ADDENDUM #01
STH 33 – GOLD STAR MEMORIAL TRAIL
DODGE COUNTY
PROJECT 1411-00-71
6/29/2026

BOARDWALK TIMBER ELEVATED WITH RAILING

Addendum No. 01
ID 1411-00-71
Revised Construction Details
June 29, 2026

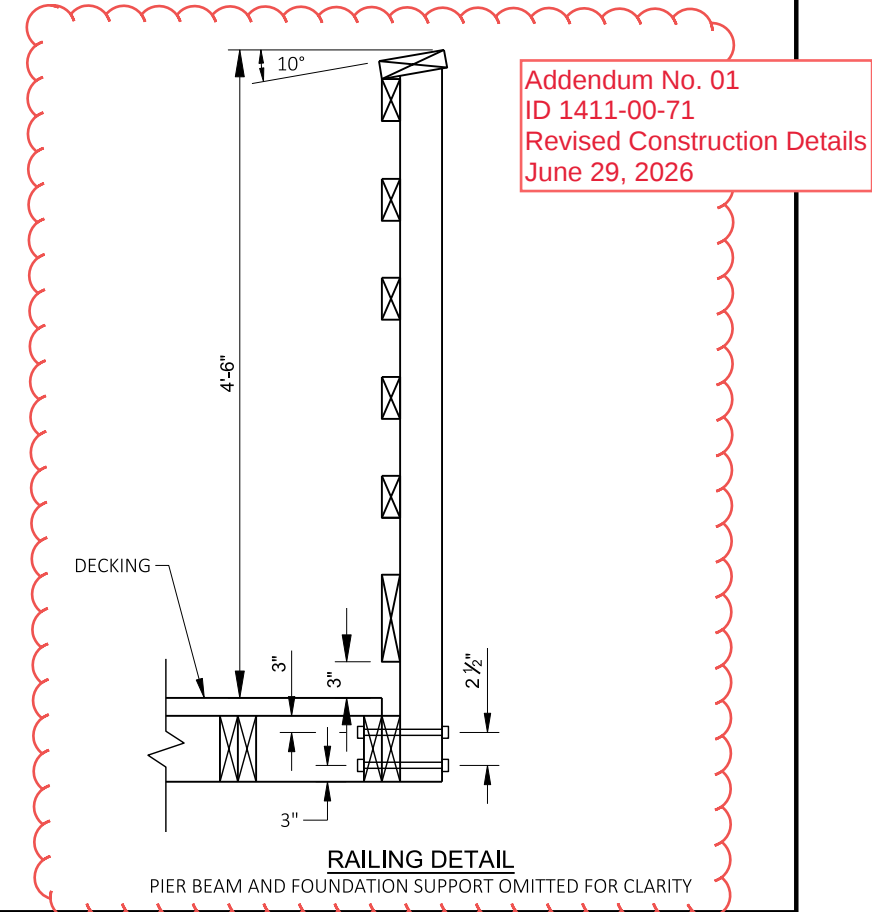
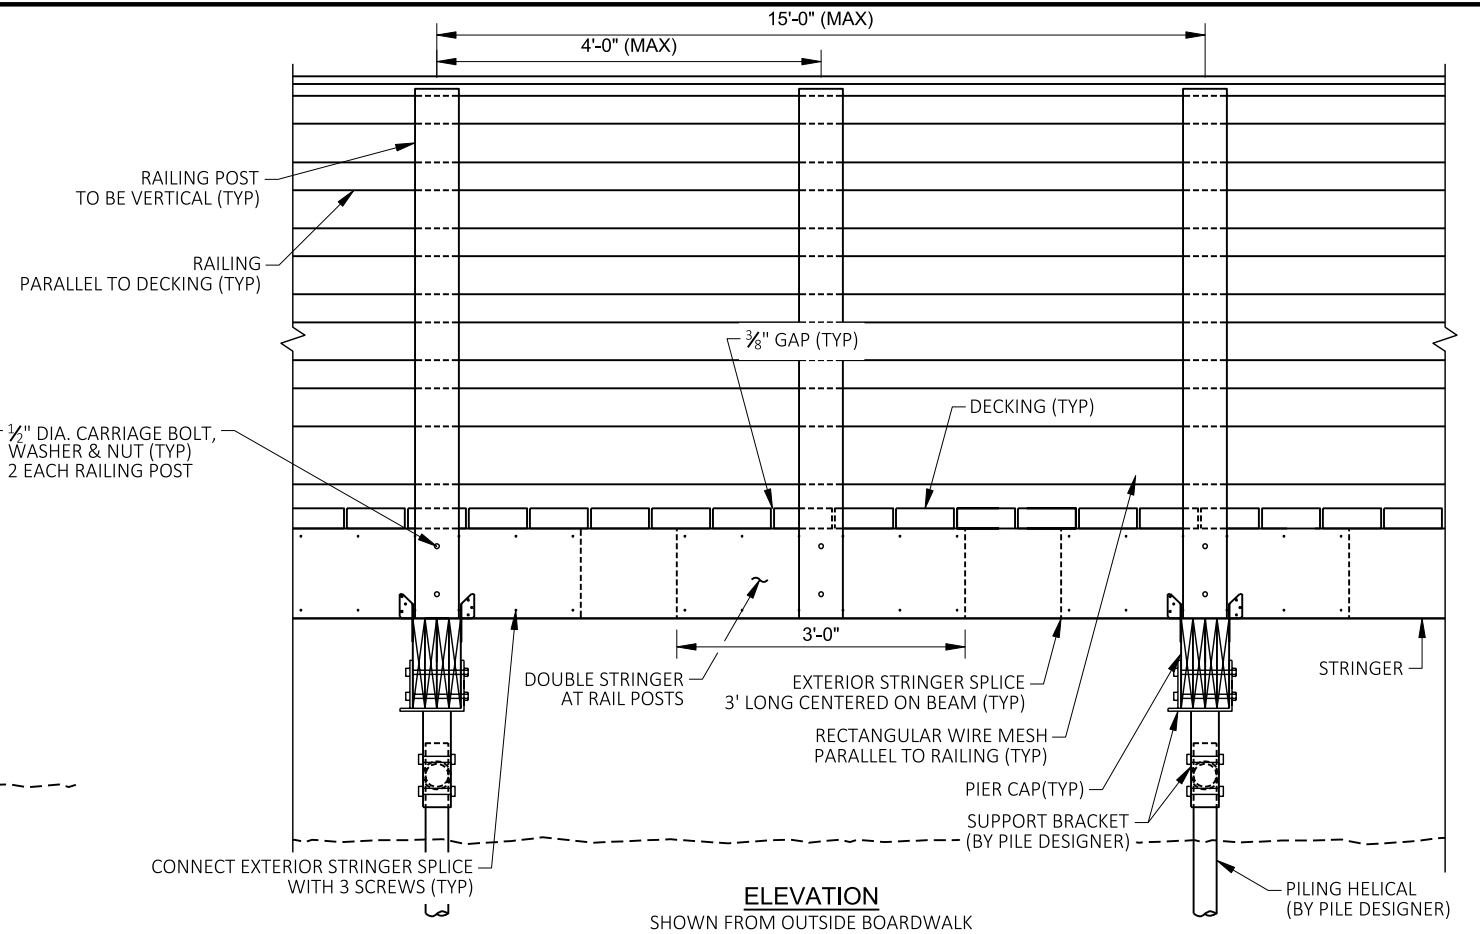
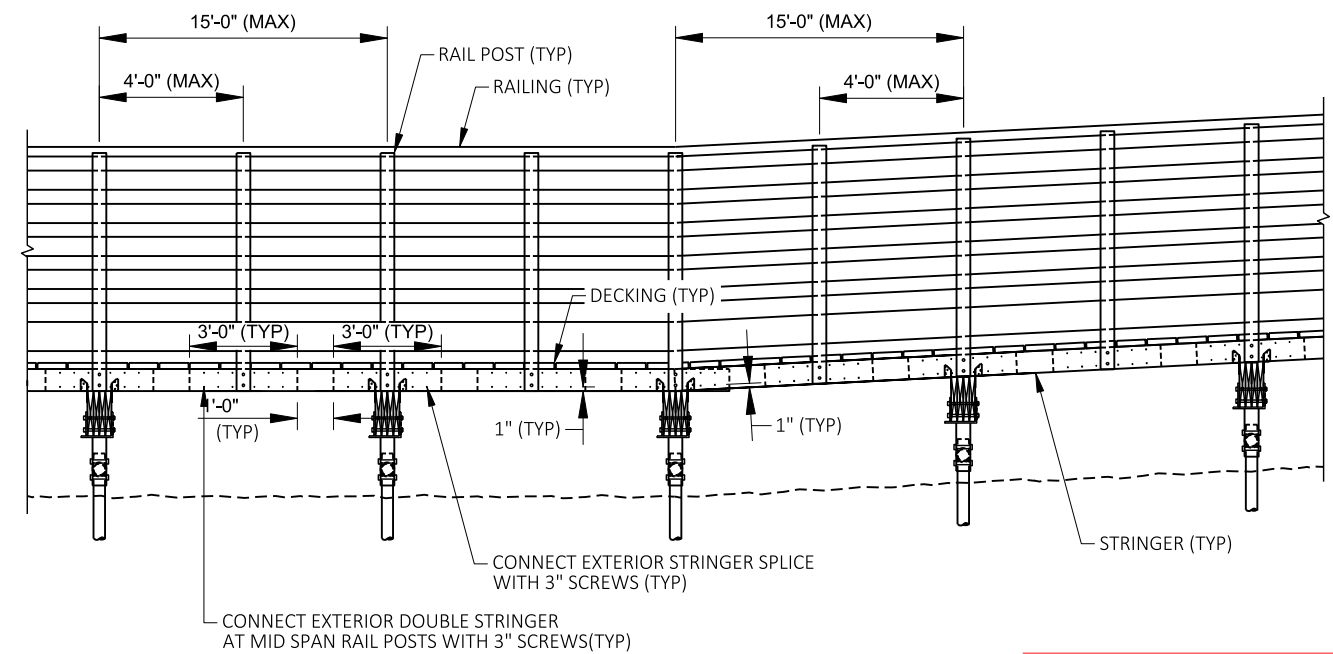
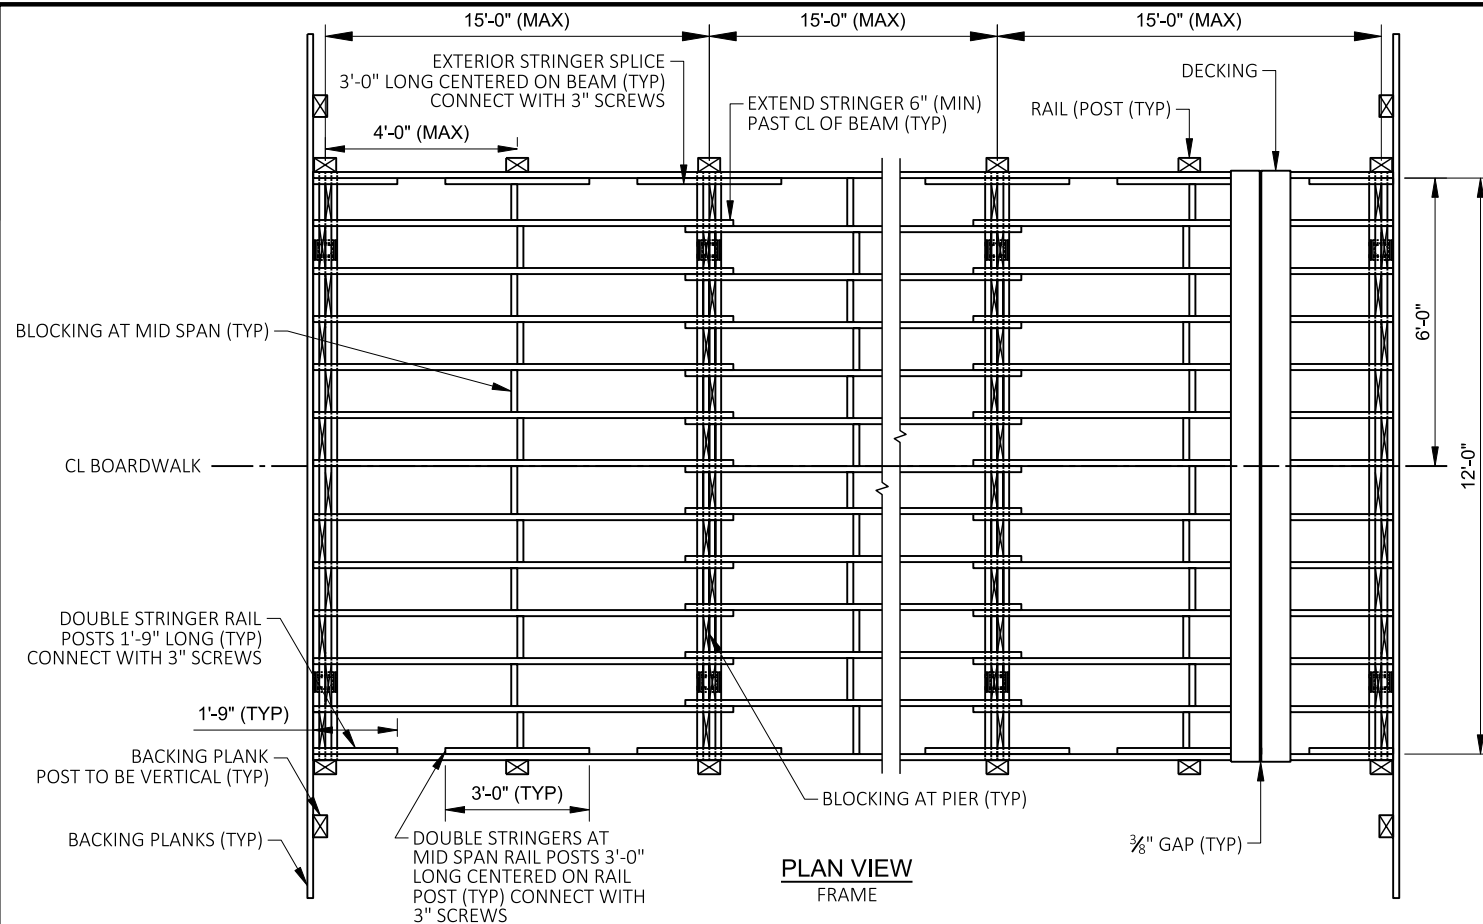
- SHEET 9: Updated railing detail.
- SHEET 10: Updated Specifications note.
